STAFF RECOMMENDATION

150 Windsor Drive

February 17, 2021

Application: Demolition; New Construction—Infill

Figure 1. 150 Windsor Ave

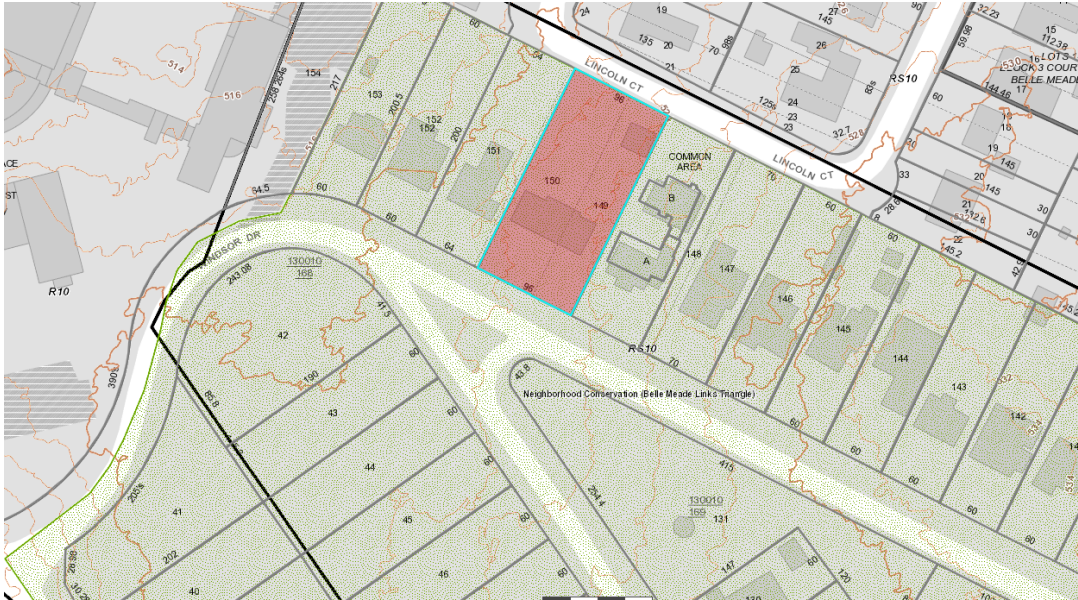
Background: 150 Windsor Drive was constructed in 1954 (Figure 1). In 2017, MHZC determined after a survey of the neighborhood that the existing house on the lot is non-contributing because its ranch form does not meet the predominate historic house form in the Belle Meade Links Neighborhood Conservation Zoning Overlay. Also in 2017, MHZC approved adding a one-half story addition on top of the ranch, which was akin to constructing infill on the lot because the overall height, scale, roof form, and style of the house would have changed. That addition was never built. This application is for a different infill design from what was approved in 2017.

Demolition: As mentioned under “Background,” because of 150 Windsor’s ranch form, which is not a predominant house form in the Belle Meade Links Neighborhood Conservation Zoning Overlay, MHZC determined in 2017 that 150 Windsor is non-contributing.

Staff therefore finds that the demolition of 150 Windsor meets Section III.B.2. of the design guidelines for appropriate demolition.

ARCHITECTURAL SITE PLAN

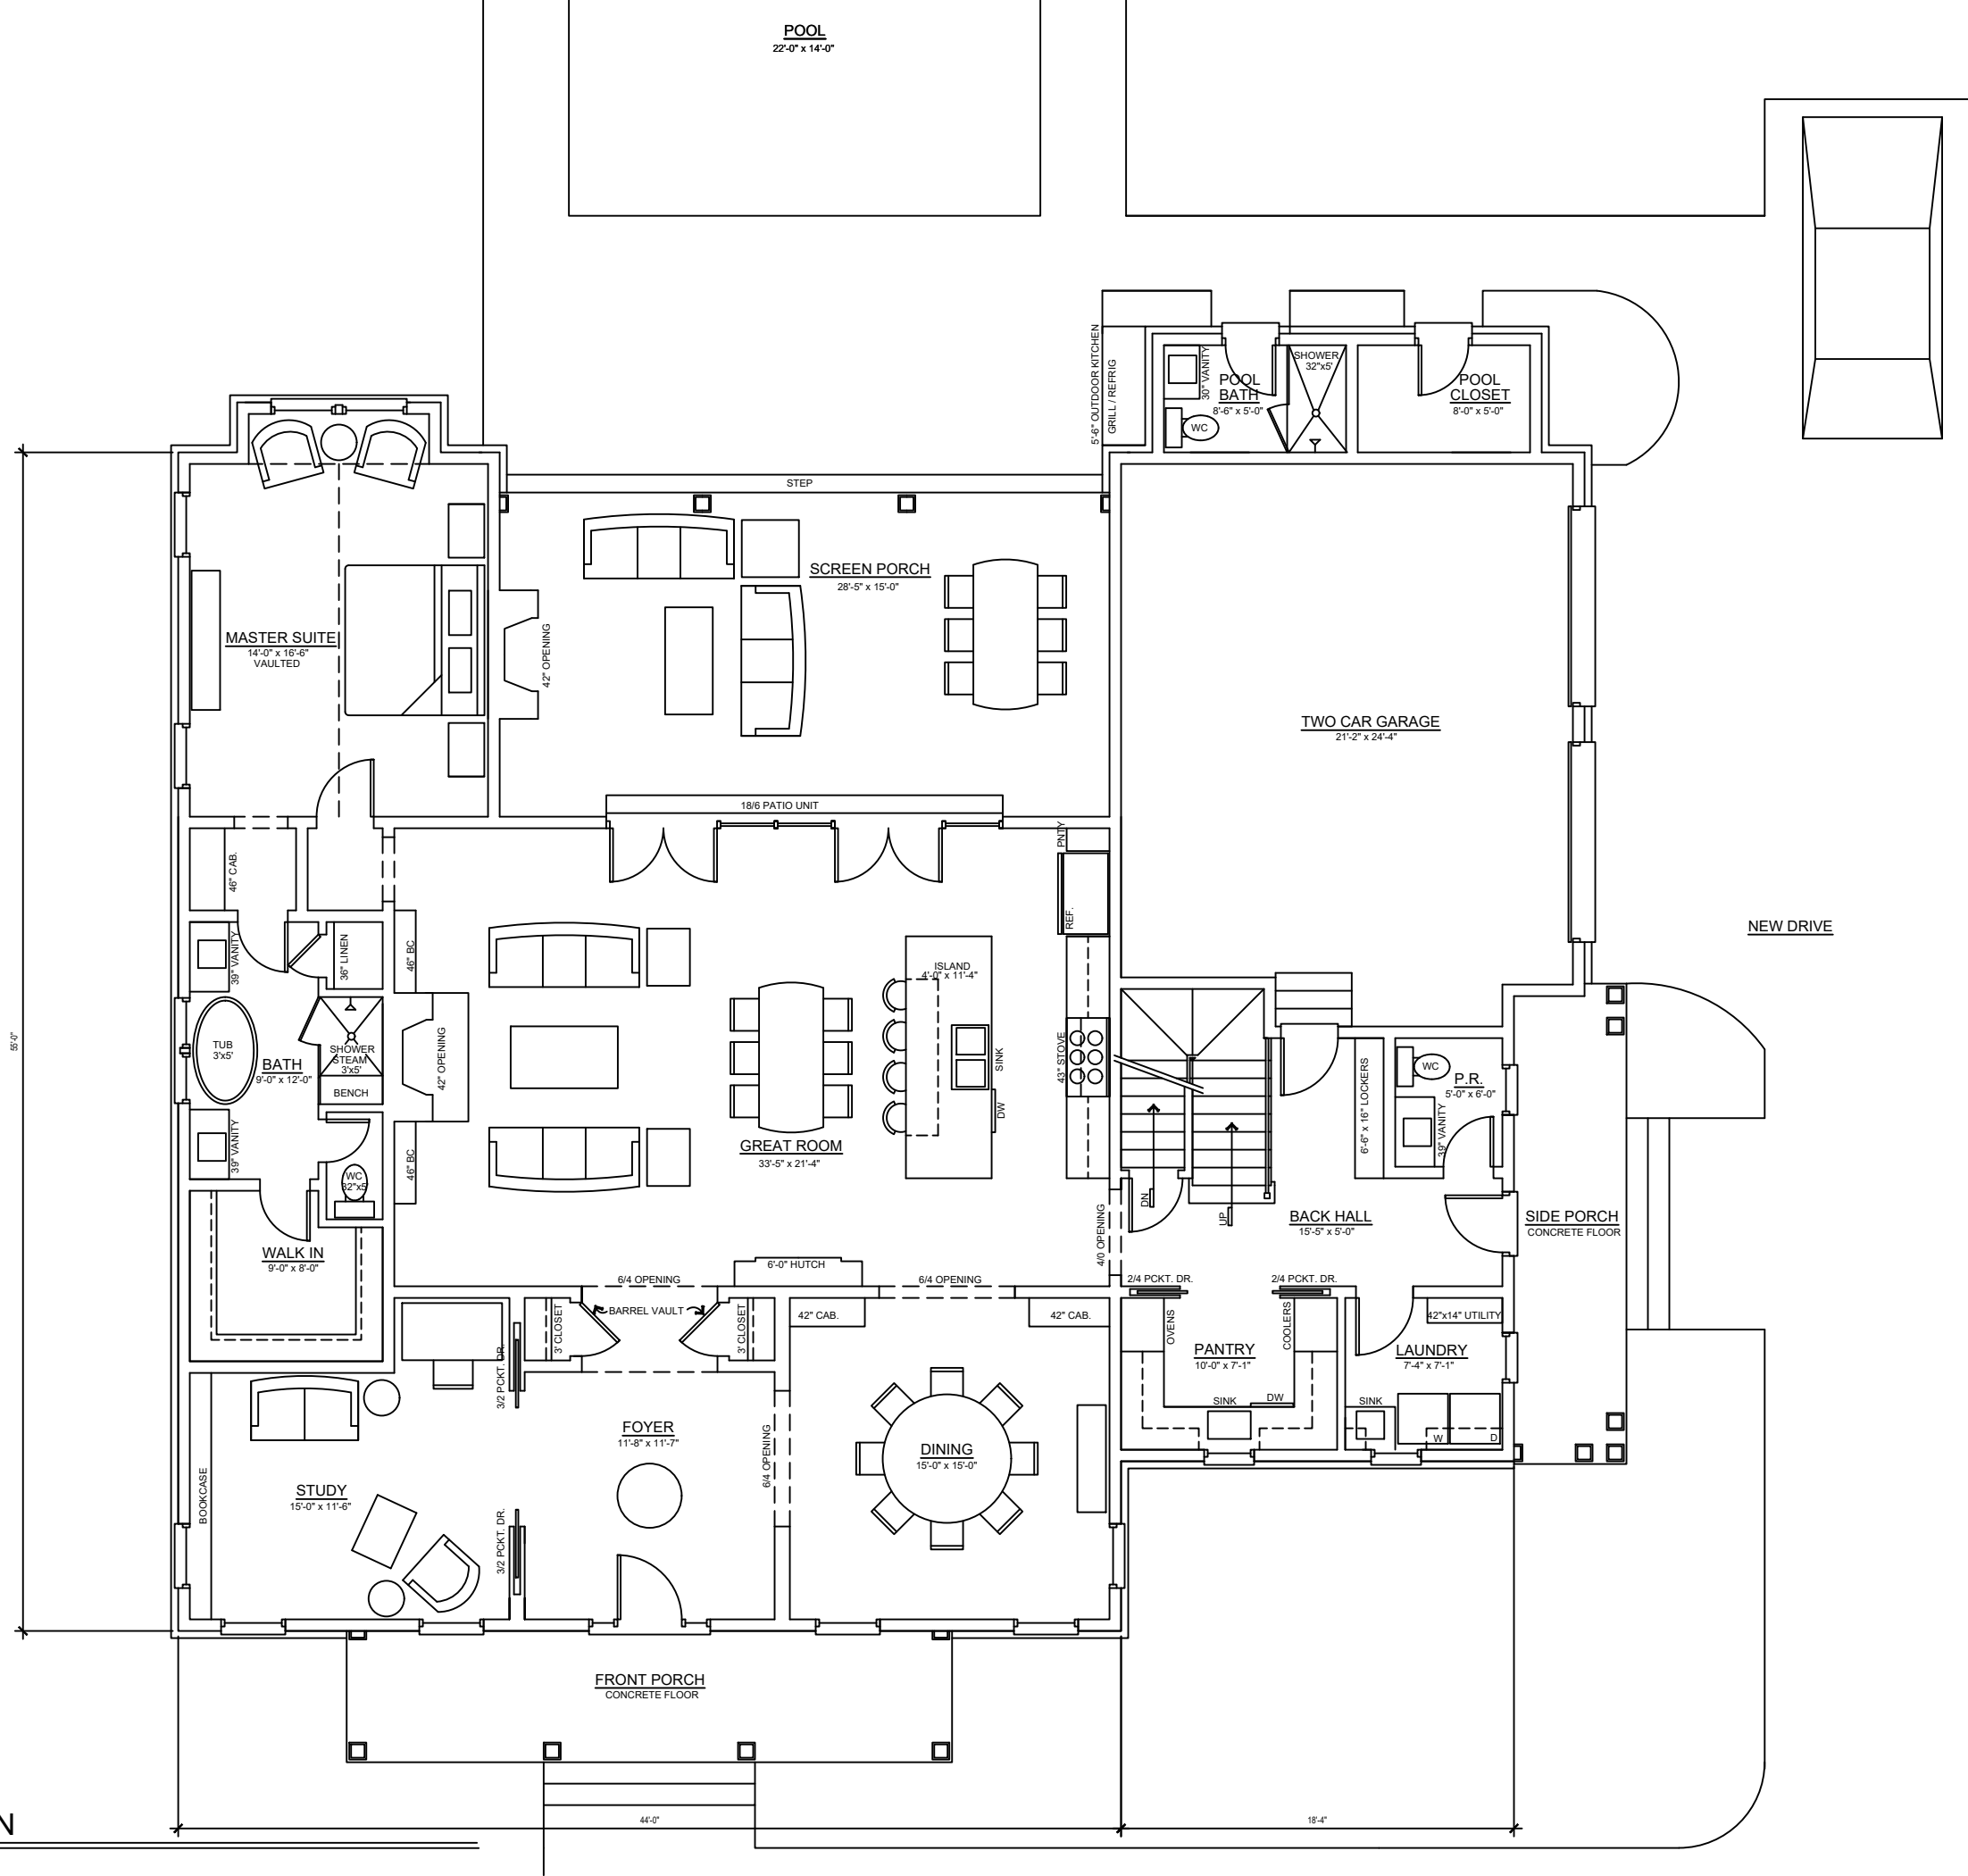
Setback & Rhythm of Spacing: The proposed infill meets all base zoning setbacks. It will be five feet (5') from the left side property line and approximately twenty-five feet (25') from the right side property line. It will be approximately fifty feet (50') from the rear property line. The front setback is proposed to be approximately forty-seven feet, six inches (47'6"), which is halfway between the front setbacks of the two houses on either side. 151 Windsor is forty-four feet (44') from the front property line and 149 Windsor is fifty-one feet (51') from the front property line. Staff finds that these proposed setbacks meet the historic context.

Orientation: The house is oriented towards Windsor Drive, with a primary entrance behind a six-foot (6') deep, centered, partial-width front porch. Vehicular access to the lot will be via the existing driveway. The site plan shows the front walkway as coming off the driveway rather than connecting to the street. This is similar to the existing walkway configuration. Windsor Drive and all of the Belle Meade Links neighborhood lack sidewalks, and some of the historic houses have walkways leading to the street, but others do not. Staff finds the proposed walkway to meet the historic context, where similar walkways are found.

Staff finds that the setbacks and rhythm of spacing to meet Section II.B.1.c. of the design guidelines.

Staff finds that the infill's orientation to meet Section II.B.1.f. of the design guidelines.
